NESO reply to consultation comments

NESO acknowledged all the comments from EDF and had a follow-up meeting to clarify their questions and concerns. NESO detailed responses and discussion notes are summarised in the table. A case study on minimum inertia policy's impact on 14th March 2025 event were included in the appendix of this note.

Case study on minimum inertia policy's impact on 14th March 2025 event.

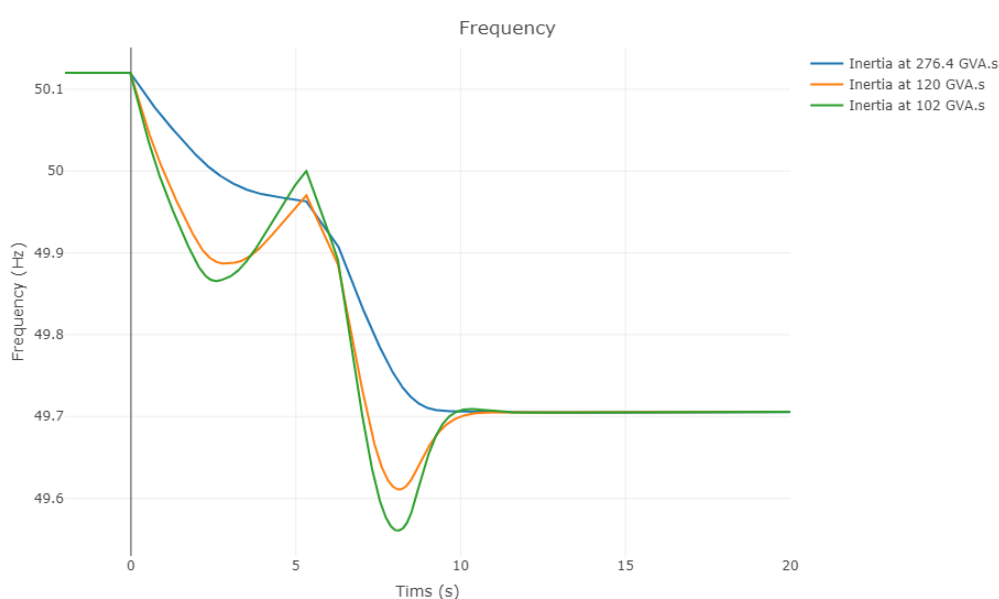
System conditions for 14th March event is shown below where the system inertia was reported as 276.4 GVA.s at the time of the event. Based on this information, below right shows the simulated frequency vs the recorded frequency.

However, there would be some difference if the system raw inertia is below the threshold where additional actions are needed.

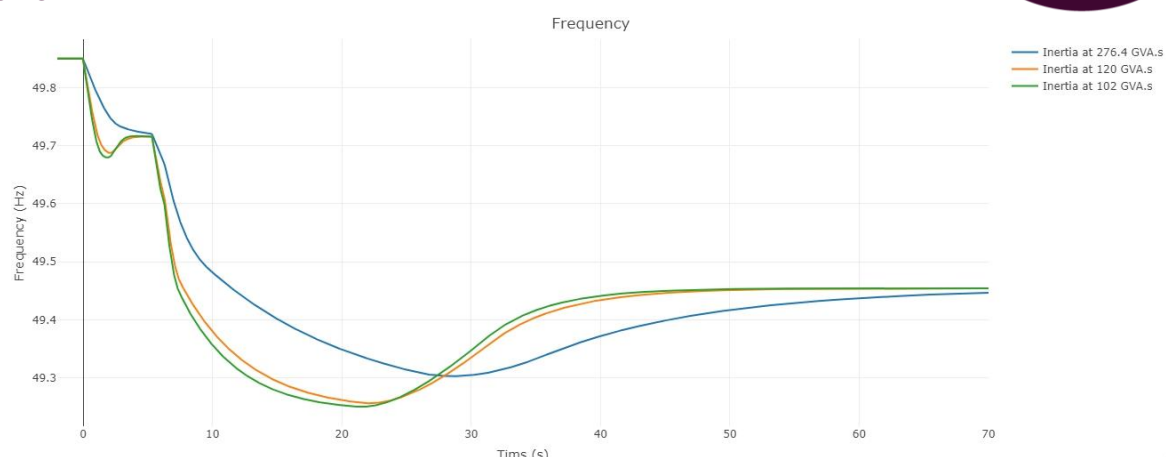
The initial frequency of this event was 50.12 Hz which provides a certain level of buffer to this event. The worst-case scenario would be considering 49.85 Hz as the initial frequency which is implemented in the response calculation process. The figure below shows the expected frequency curves if initial frequency was 49.85 Hz.

The frequency drop can be contained before 49.2 Hz, i.e. no LFDD risk for the worst-case scenario. However, the frequency struggles to recover within 49.5 Hz in 60 second since this event is not a secured loss. If this is the case, Control Room will need to instruct reserve products to bring frequency back within 49.5 Hz and the operational limit.
